## **BEARD SUBDIVISION**

The plat illustrates the proposed 6.4± acre, two-lot subdivision which is located on the West side of Monarch Drive West at its South terminus, extending to the West terminus of Wolf Creek Drive North, and extending to the East terminus of Jalama Drive, and is in Council District 6. The site is served by public water and sanitary sewer.

APPLICATION NUMBER 4 DATE July 6, 2006

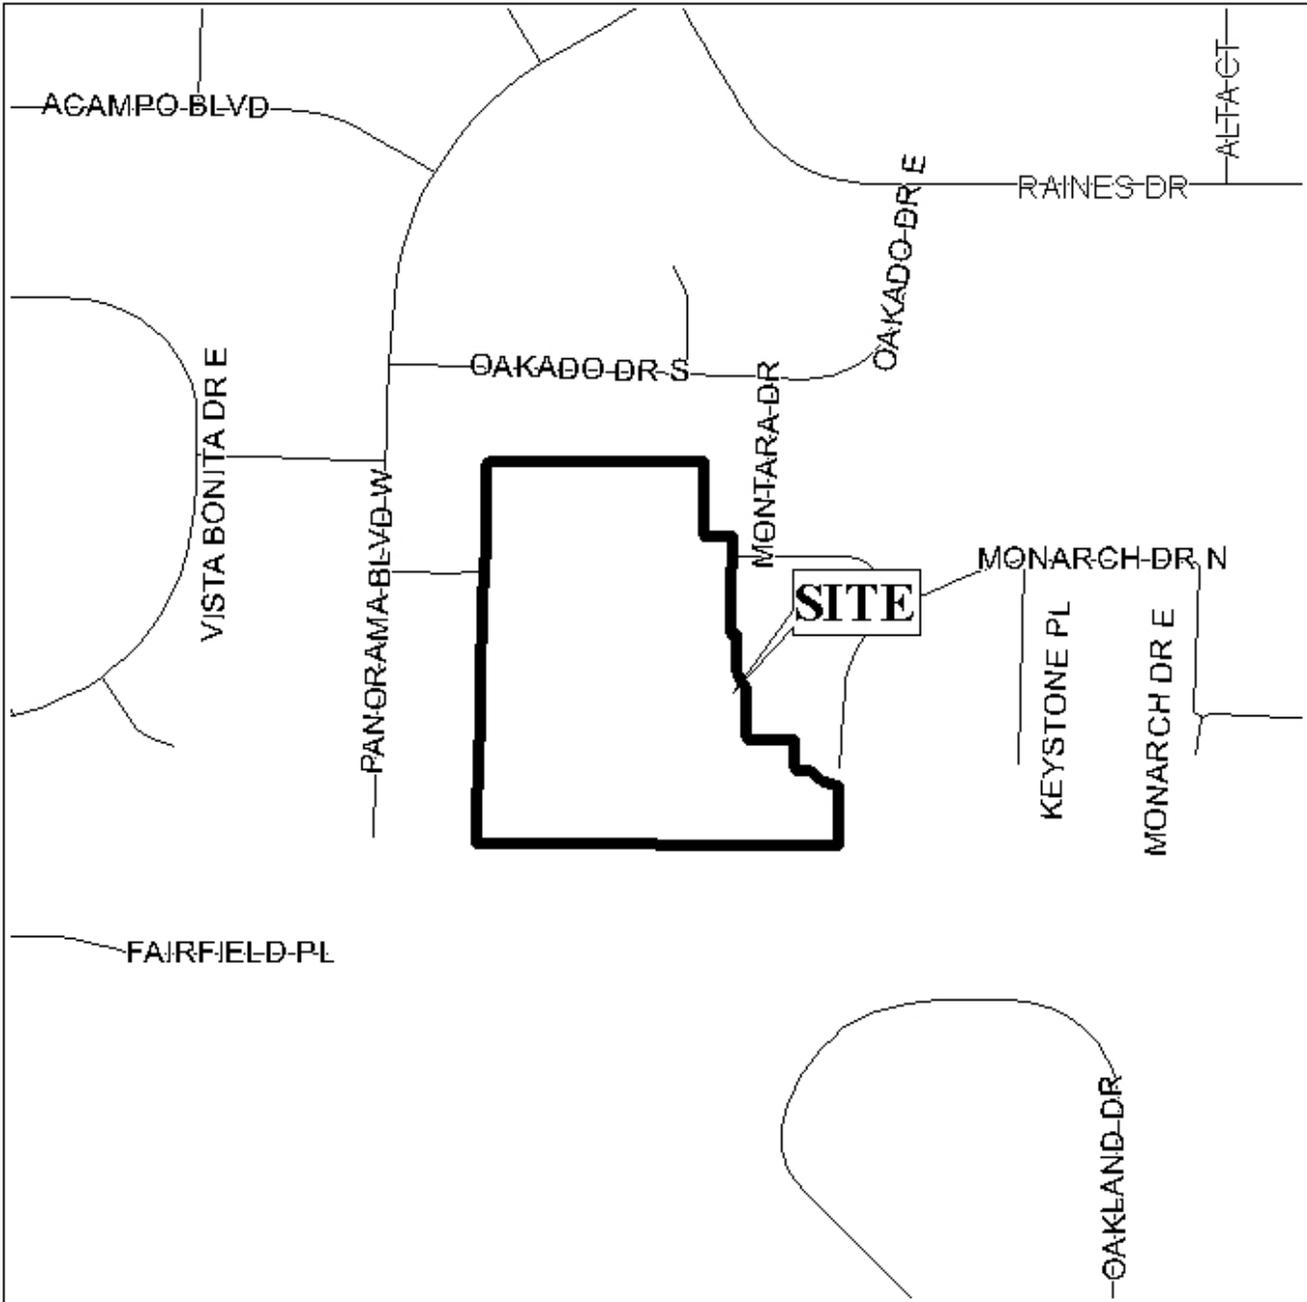
The site fronts Wolf Creek Drive North and South and Jalama Drive, all of which have 50-foot rights-of-way. Proposed lot B does not appear to have curb cuts to these streets, but any future curb cuts would be subject to Traffic Engineering approval for their size, location, and design. As a means of access management proposed Lot A should be limited to a single curb cut.

The plat illustrates the 25-foot building setbacks for Lot A, but not for Lot B; these should be required on the final plat.

The plat meets the minimum requirements of the Subdivision Regulations and is recommended for Tentative Approval, subject to the following conditions: 1) the placement of a note on the final plat stating that size, location, and design of all curb cuts is subject to Traffic Engineering approval; and 2) the placement of a note on the final plat stating that Lot A is limited to a single curb cut.
